AIA[®] Document G716[™] – 2004

Request for Information (“RFI”)

Harrison, Town-Village Recreation Center Phase 2
270 Harrison Avenue
Harrison, NY 10528

020

Referencing: M-204 Dated 07-01-24

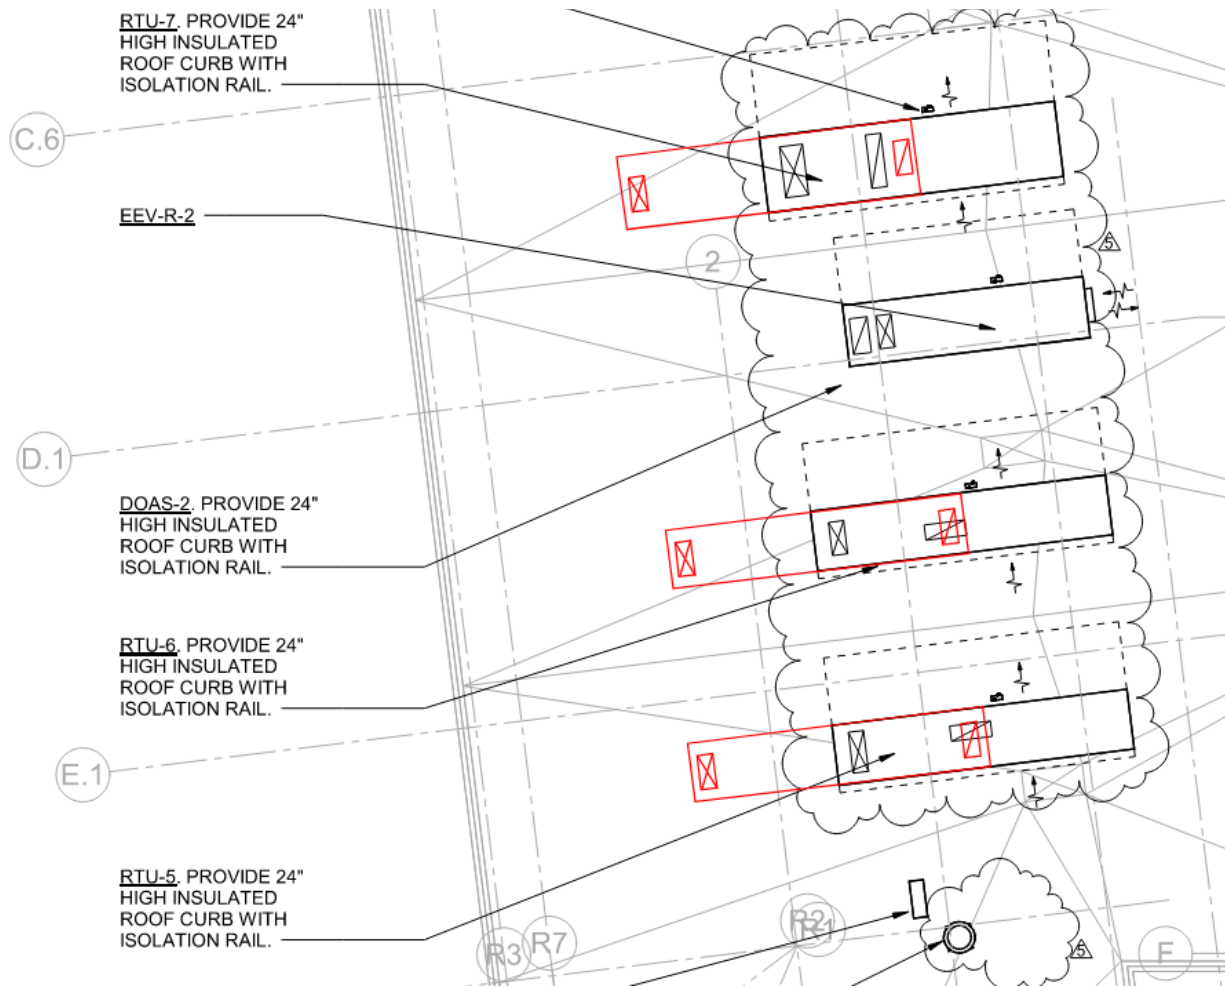
The Mechanical Plans show RTU 5,6, and 7 on the roof having the return and supply connections close together on the bottom of the units. These connections are actually on opposite ends of the units. In order for the duct design to work below on the second floor, these units will have to be shifted plan west of design locations. Please advise if this is acceptable. For reference see the marked-up image below. The red mark ups show the approximate new locations for RTU-5,6,7.

Location of RTU-5, 6, and 7 shall remain as is per Contract Documents. The return air discharges into insulated roof curb plenum. Mechanical Contractor shall coordinate return air duct with roof curb bracing.

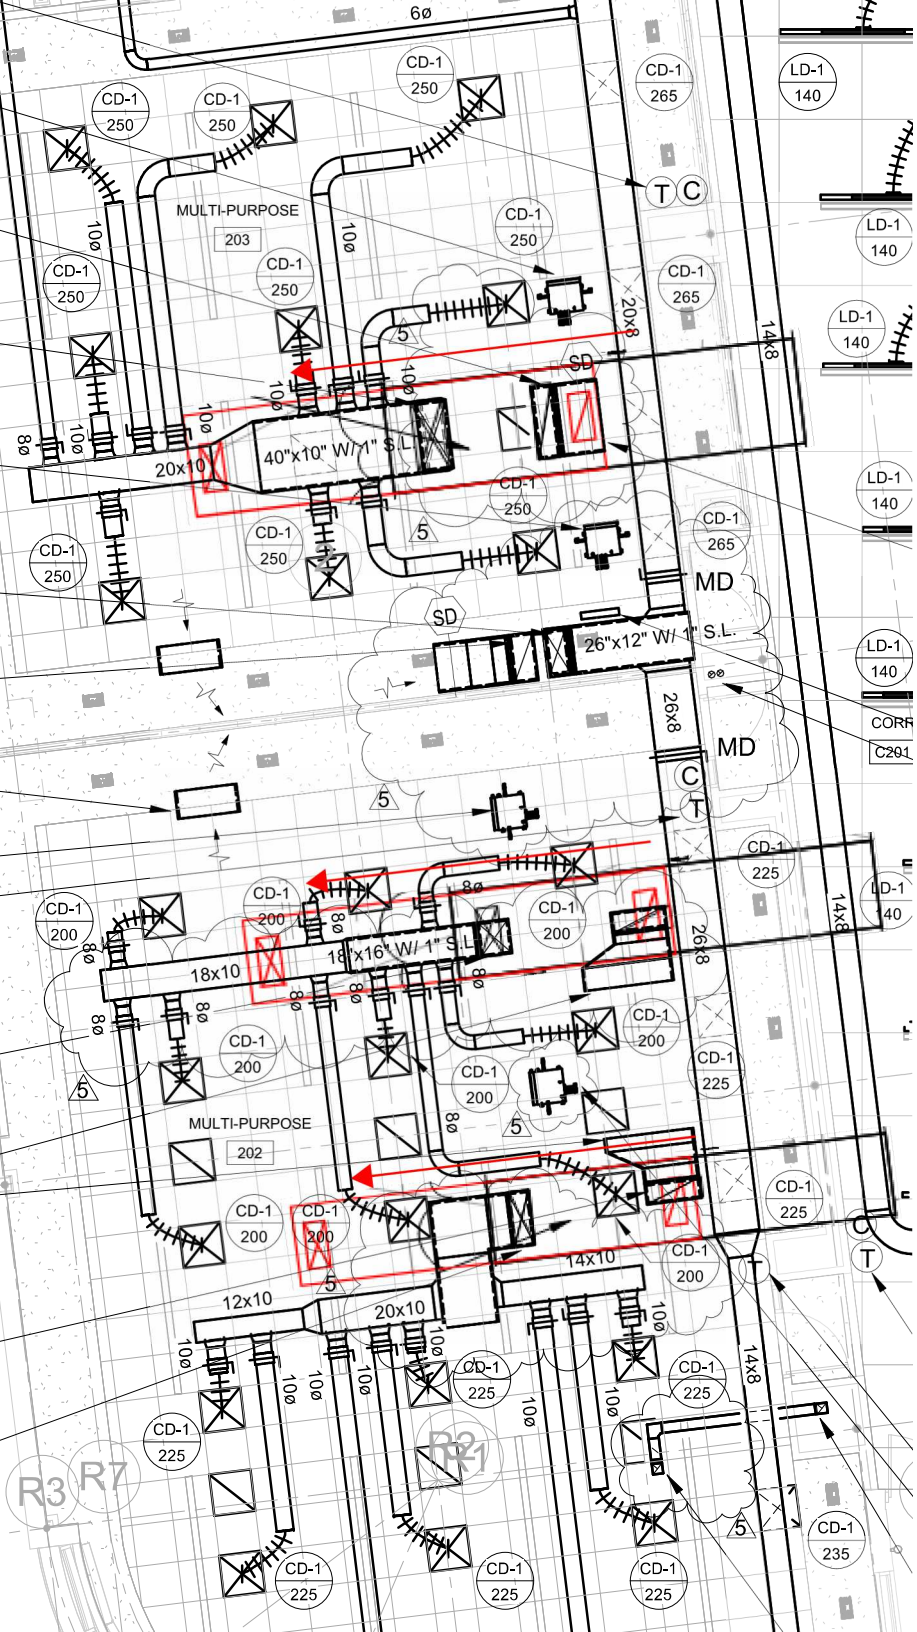
RTUs 5-7 please check the duct connections. Can the RTUs be shifted west as shown in the marked up M-203 & M- 204 Sks

Please see the following RFI raised by Taconic H&C regarding the change in supply/return air connections for RTUs 5-7. As the units have been lengthened in the most recent submittal, the duct connections are no longer compatible with the original plans. Please advise if the RTUs can be shifted west as depicted in the marked up M-203 & M-204 sketches.
